Work Order ID 77433

Item Name: Crosstube Aft

DRAWING NO. D412-664-243	TITLE CROSSTUBE ASSEMBLY (412 HI AFT)	REV. E	DART AEROSPACE LTD ENGINEERING ORDER		D.E.O. NO. D412-664-243-E-1	SHEET NO. SHEET 1 OF 2	SCALE NTS
DRAWN	CHECKED	MFG. APPR.	APPROVED		DE APPR.		
DATE 11.03.31	DATE 11/03/31	DATE 11.03.31	DATE 11/03/31		DATE 11-03-31

DRAWING NO. D412-664-243	TITLE CROSSTUBE ASS'Y (412 HI AFT)	REV. E	DART AEROSPACE LTD ENGINEERING ORDER		D.E.O. NO. D412-664-243-E-2	SHEET NO. SHEET 1 OF 1	SCALE NTS
DRAWN <i>JP</i>	CHECKED <i>ASS</i>	MFG. APPR. <i>EE</i>	APPROVED <i>MP</i>		DE APPR. <i>#</i>		
DATE 11.09.07	DATE 11.09.19	DATE 11.09.19	DATE 11.09.19		DATE 11.09.19

**D412-664-243
ASSEMBLY DETAIL**

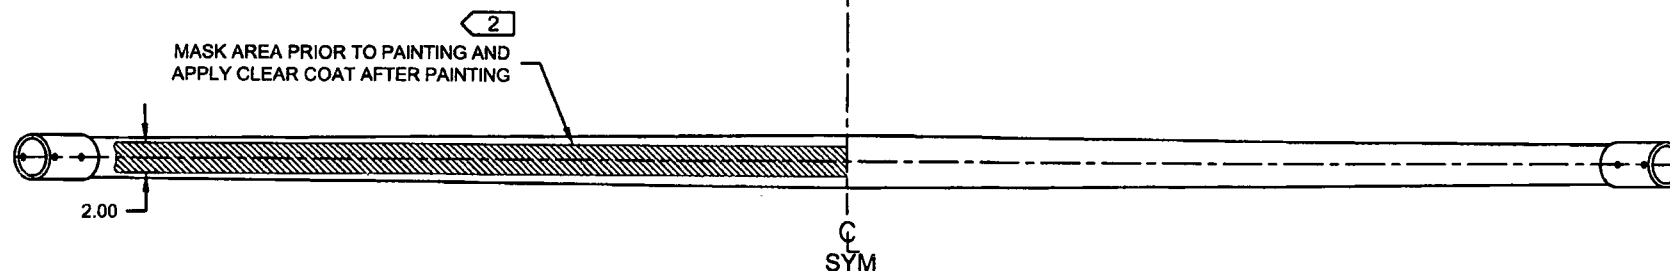
DRAWING NO. D412-664-243	TITLE CROSSTUBE ASSEMBLY (412 HI AFT)	REV. E	DART AEROSPACE LTD ENGINEERING ORDER	D.E.O. NO. D412-664-243-E-1	SHEET NO. SHEET 2 OF 2	SCALE NTS
DRAWN <i>[Signature]</i>	CHECKED <i>[Signature]</i>	MFG. APPR. <i>[Signature]</i>	APPROVED <i>[Signature]</i>	DE APPR. <i>[Signature]</i>		
DATE 11.03.31	DATE 11.03.31	DATE 11.03.31	DATE 11.03.31	DATE 11.03.31

IS:

D3189-1 CHAFING SHIELD (1, INSTALLED OVER PROSEAL 890)
MS21920-28 CLAMP, 2X
2 PL

WAS:

D2856-600-1009 ABRASION STRIP
D3189-1 CHAFING SHIELD (1, INSTALLED OVER ABRASION STRIP)
MS21920-28 CLAMP, 2X
2 PL
